To	Ben Fryer	From	Matt Rowbotham
Fax No		Date	12/12/07
Company	Doug Gow and Associates	Reference	Preliminary Geotechnical Assessment Workshop Letter
cc		Page	1 of
Subject	Preliminary Geotechnical Assessment - The Lakes Estate Stages 1.2 to 9.2

Outlined below is a summary of the geotechnical issues which will need consideration for final design and development at the new release of land for The Lakes Estate (Stages 1.2 to 9.2). It is hoped that this preliminary information is helpful for your initial discussions. If you have any questions, please contact Matt Rowbotham or Iain Turner at our Coffs Harbour Office.

client:	DOUG GOW AND ASSOCIATES PTY LTD
project:	THE LAKES ESTATE STAGES 1.2 to 9.2
title:	ROADS LIKELY TO REQUIRE CUT AND FILL EARTHWORKS
project no:	GEOTCOFH02233AA
figure no:	FIGURE

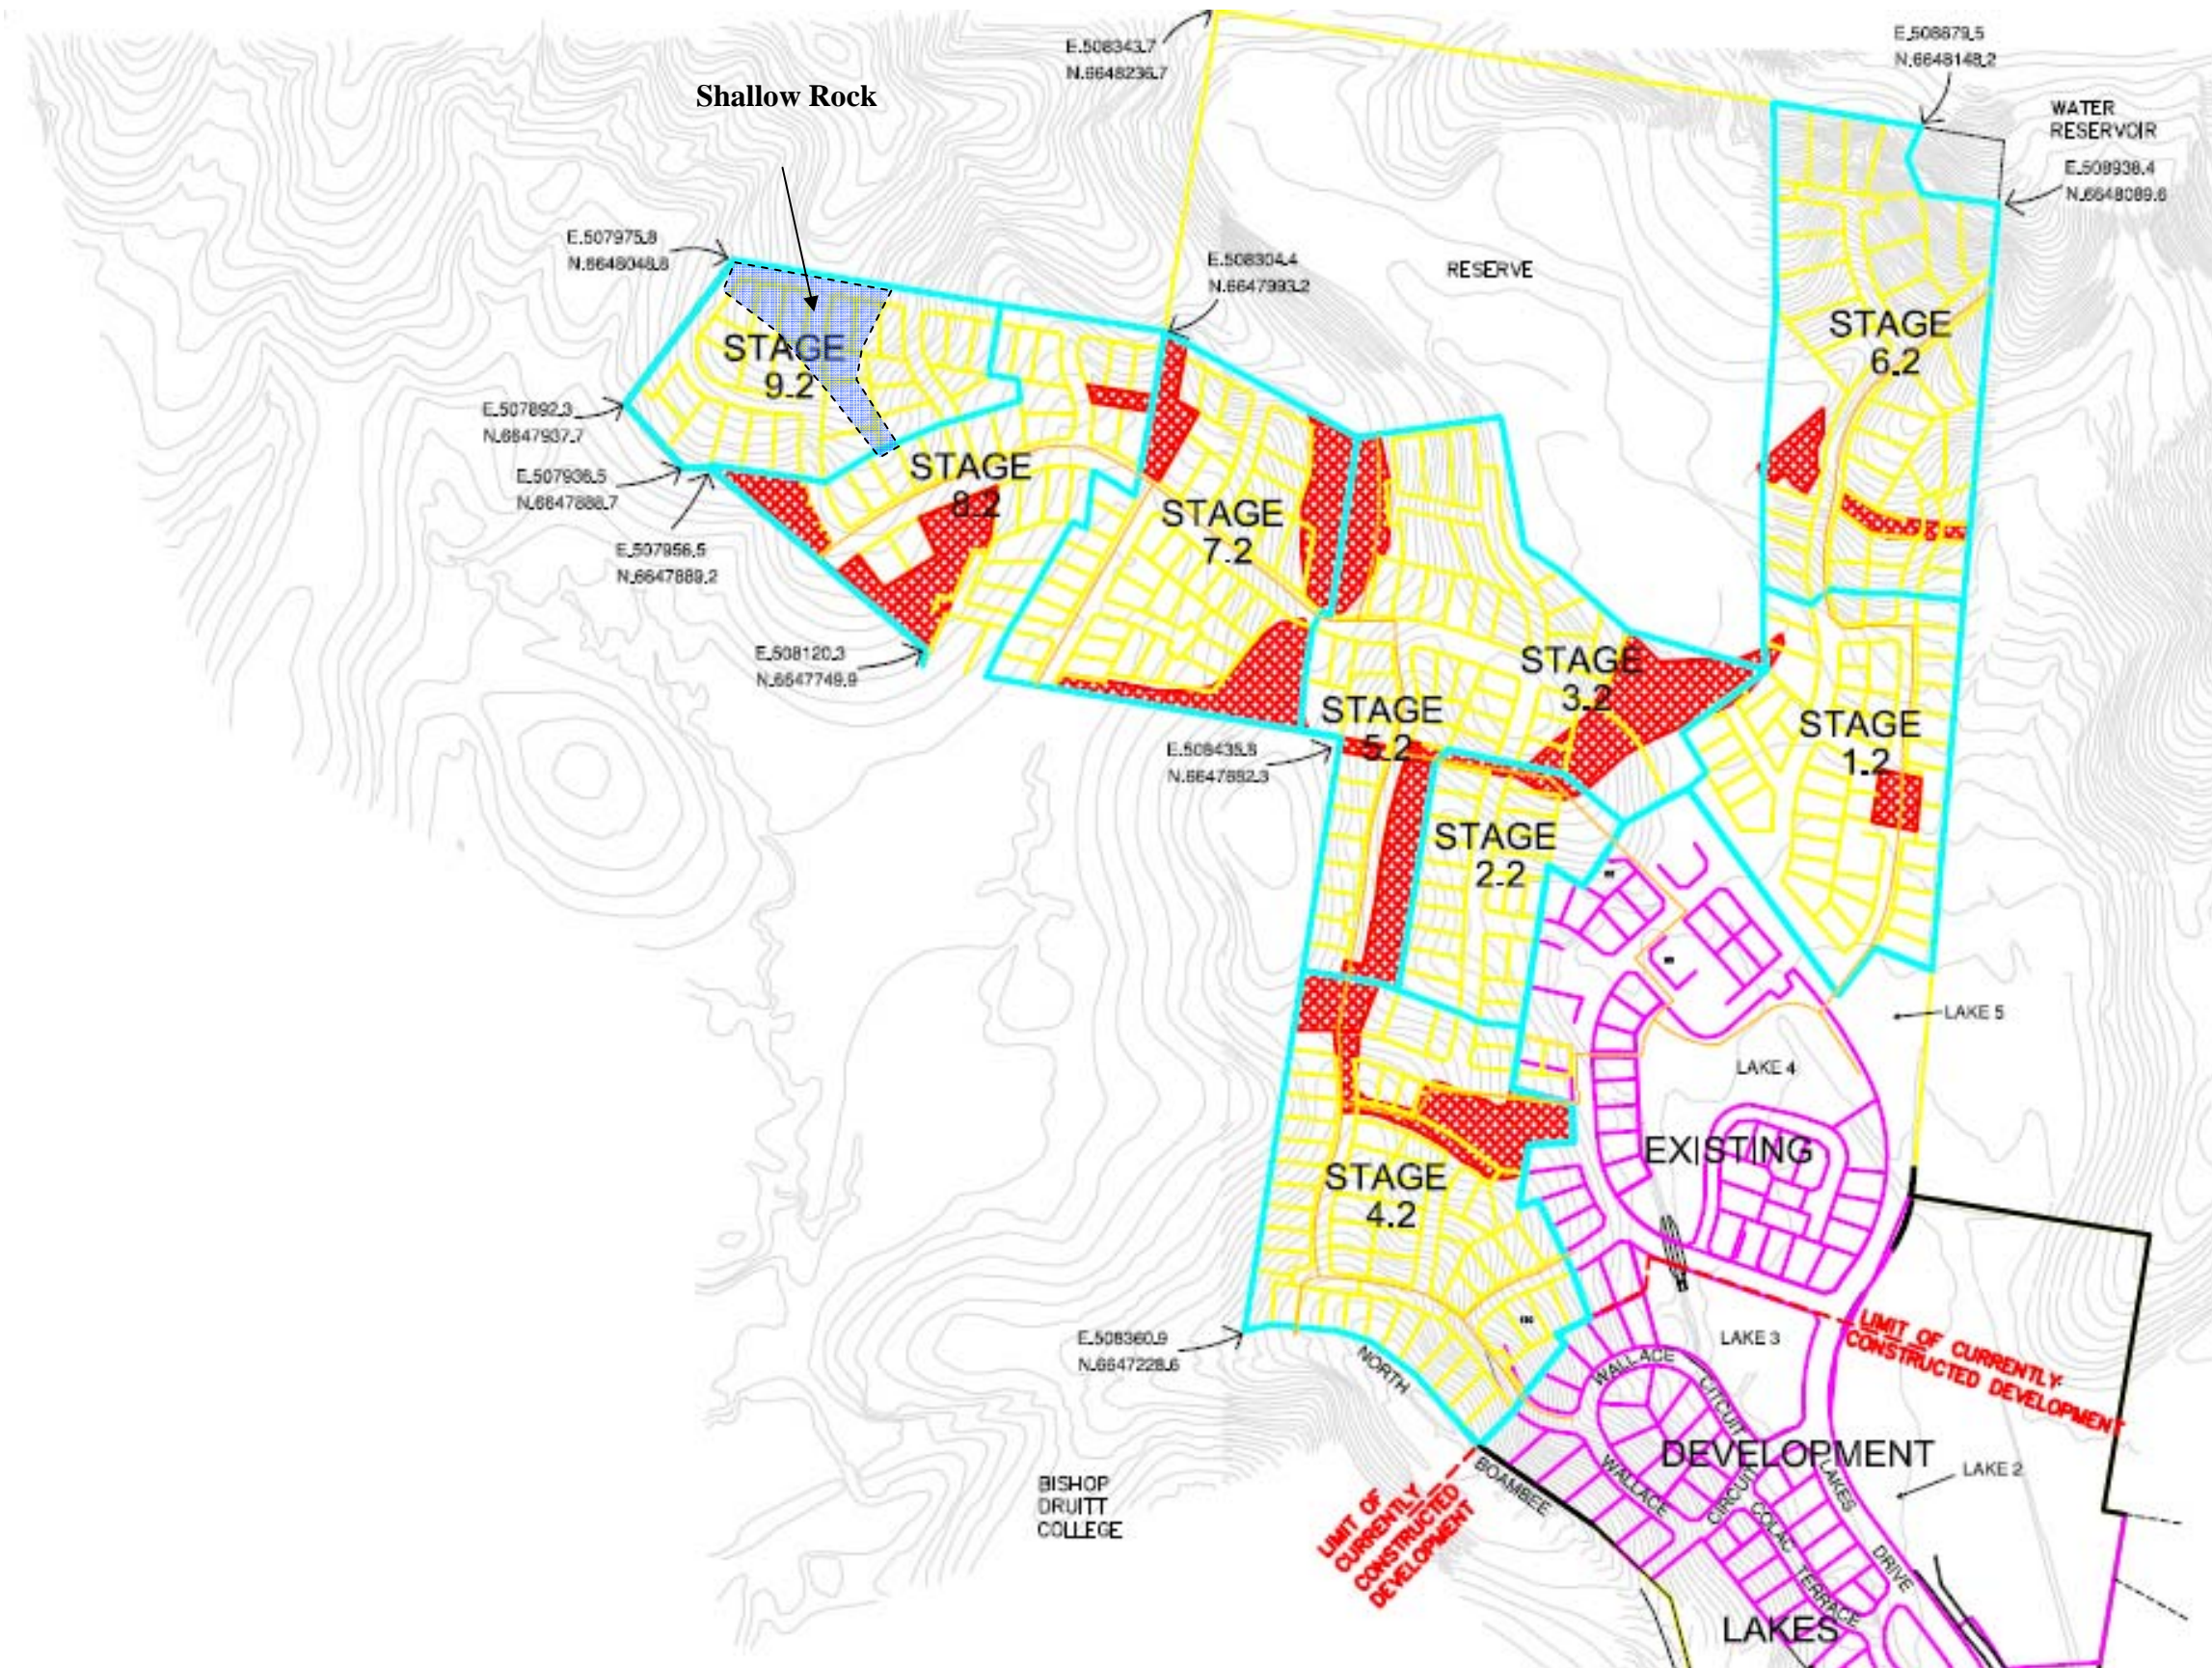
The design plans provided to date indicate that some of the access roads are planned along the sides of watercourses or steep slopes. Roads located in these areas will require cut and fill earthworks to effectively bench/key the roads into the sides of the hillslopes.

Depending on the slope angles and the space provided for the roads their final design may need to incorporate retaining walls on the high side or low sides of the roads. For permanent batter slopes cut and fill batters should typically be constructed no steeper than 1V:2H (26°). The provision of free drainage from slopes will be essential for their maintenance.

A plan is attached indicating critical locations.

client:	DOUG GOW AND ASSOCIATES PTY LTD
project:	THE LAKES ESTATE STAGES 1.2 to 9.2
title:	SITE PLAN OF AREAS WITH SHALLOW BEDROCK
project no:	GEOTCOFH02233AA
figure no:	FIGURE

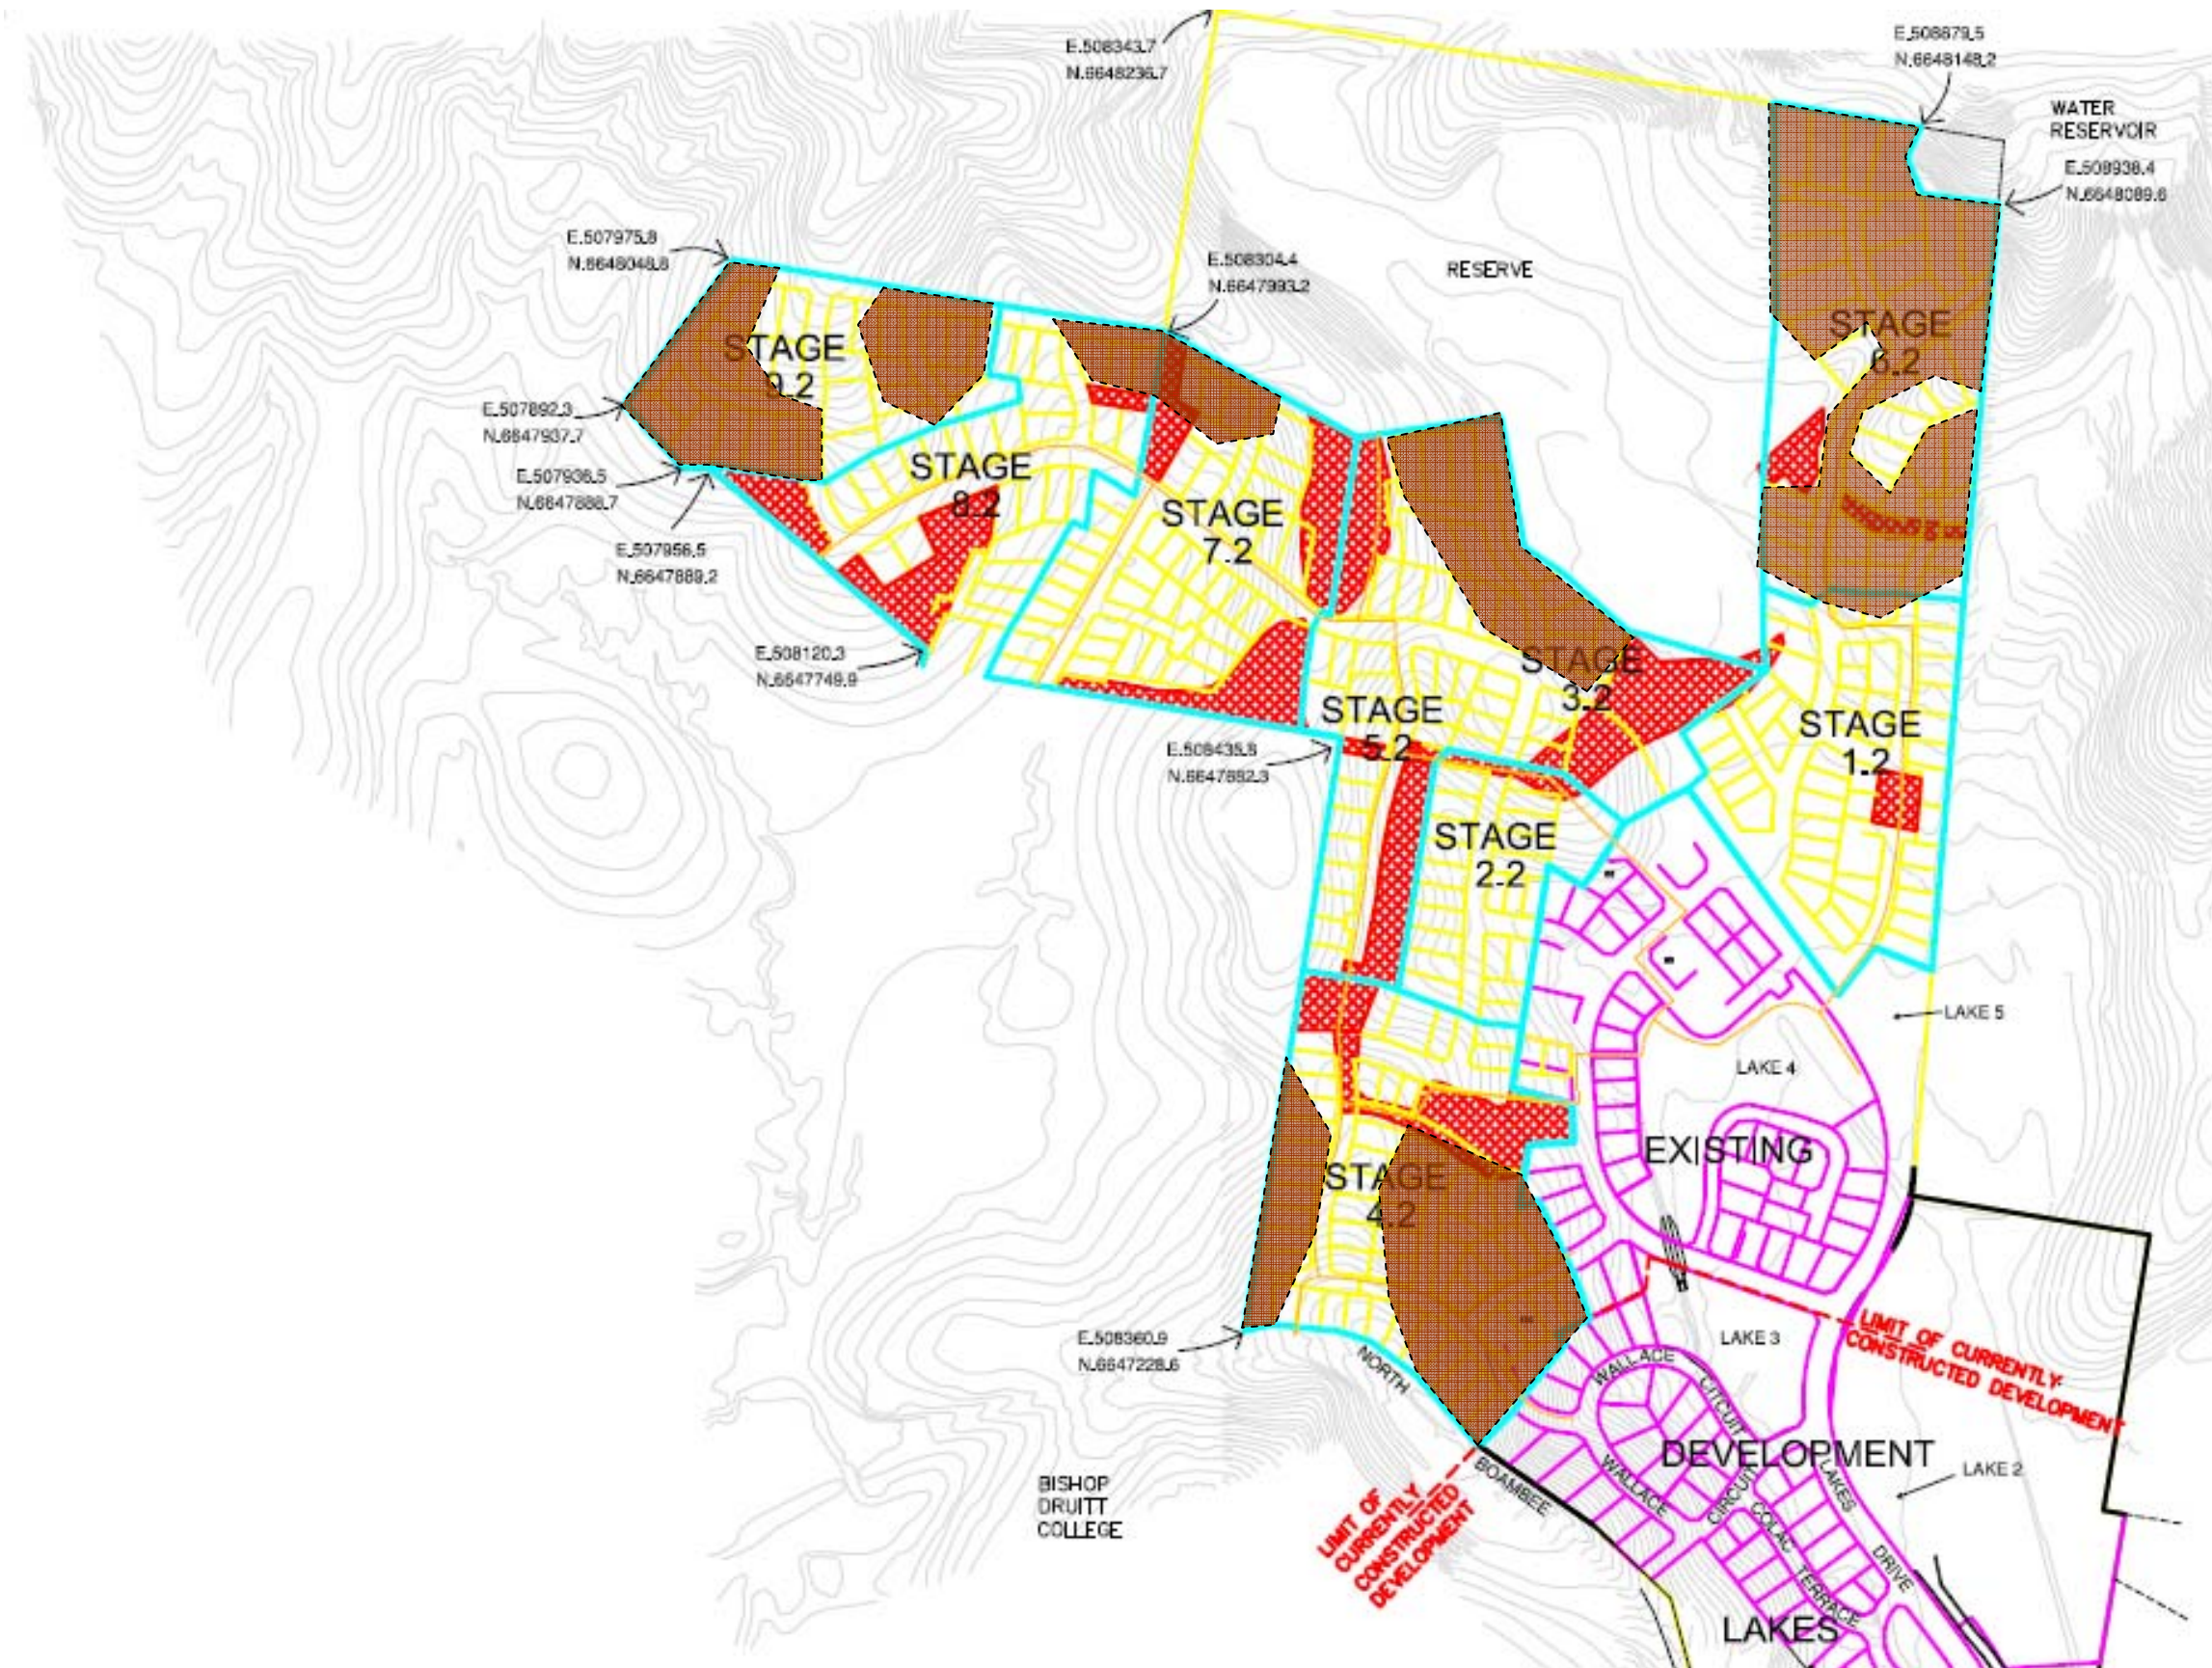
The top of the ridge in the far south-western end of the site has a shallow cover of soil overlying high strength meta-siltstone. In some areas the bedrock is exposed at the surface. This will provide adequate bearing capacity for the proposed houses. Further investigation to include core drilling into the bedrock will help with assessment of its capacity to withhold uplift on piles or anchors that are extended into the bedrock. There might be increased construction costs associated with difficult excavation into strong rock for footings or services. A plan is attached showing the location of shallow or exposed bedrock.
